Change No. 1
License No. DPR-19

SAFETY EVALUATION BY THE DIVISION OF REACTOR LICENSING

DRESDEN NUCLEAR POWER STATION UNIT 2

PROPOSED CHANGE NO. 1 TO TECHNICAL SPECIFICATIONS

Figure 1.1.1 (Revision 1) Core Thermal Safety Limit

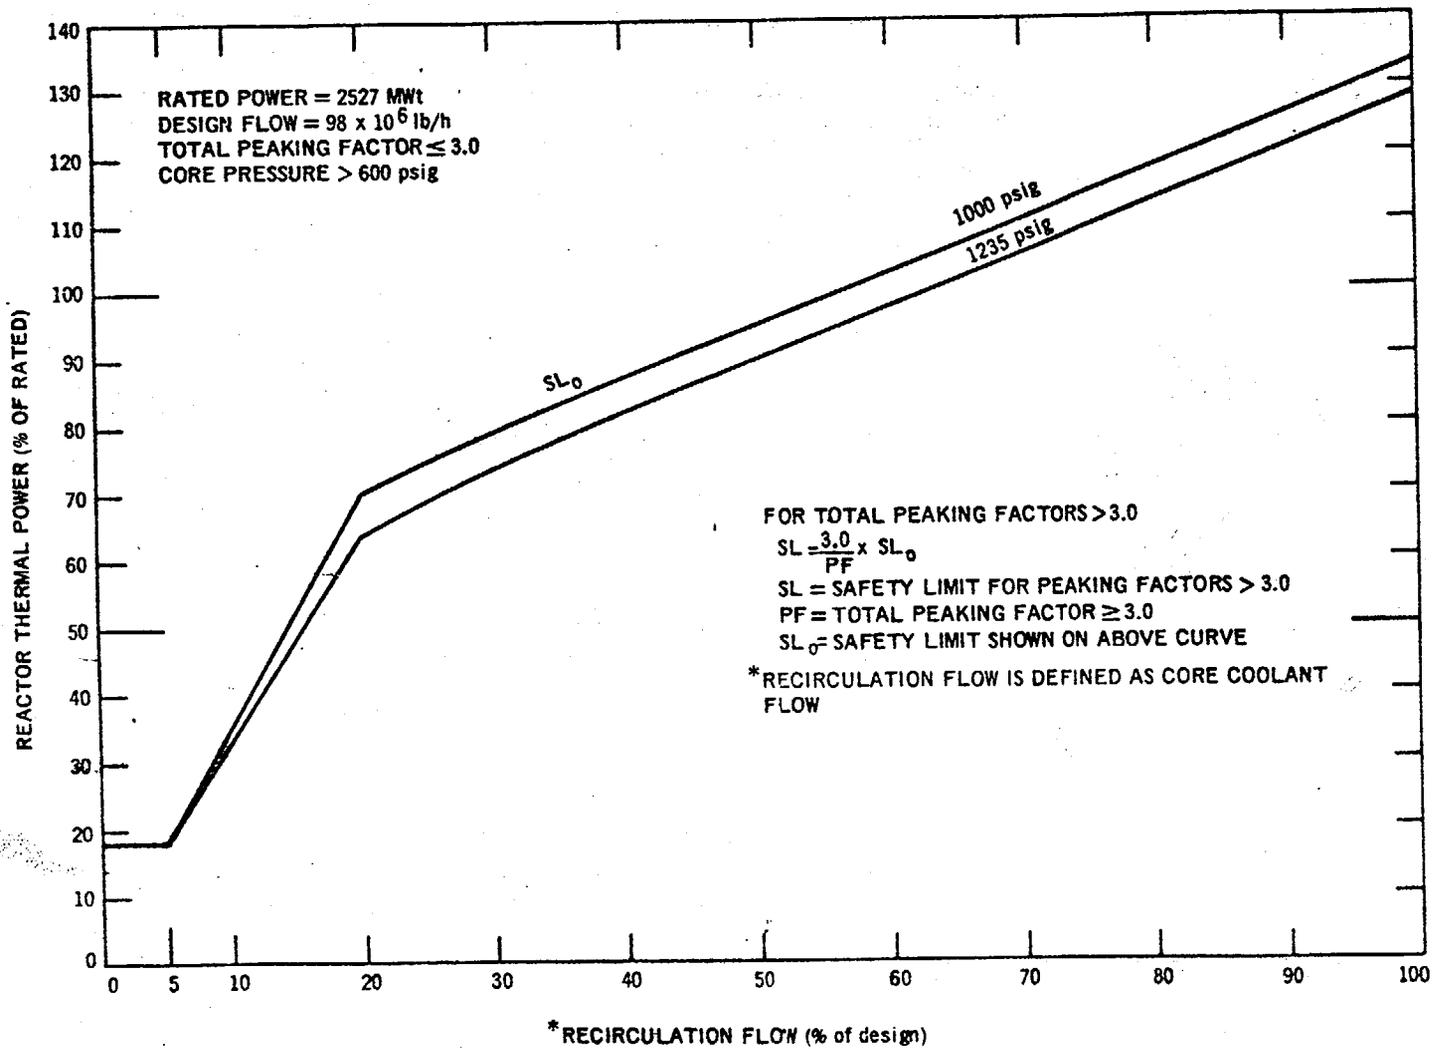
We have reviewed your Proposed Change No. 1, dated May 22, 1970, requesting changes to Figure 1.1.1 and Section 1.1.B to the Technical Specifications of Provisional Operating License No. DPR-19. The proposed changes would extend the fuel cladding safety limit, based on a minimum critical heat flux ratio (MCHFR) of 1.0, to include the region of operation between 5% and 20% core coolant flow.

On page 9, replace Figure 1.1.1 - Core Thermal Hydraulic Safety Limit - with the attached Figure 1.1.1 (Revision 1).

On page 13, delete the third sentence of the first full paragraph and replace with: "The lower curve is based on a pressure of 1235 psig."
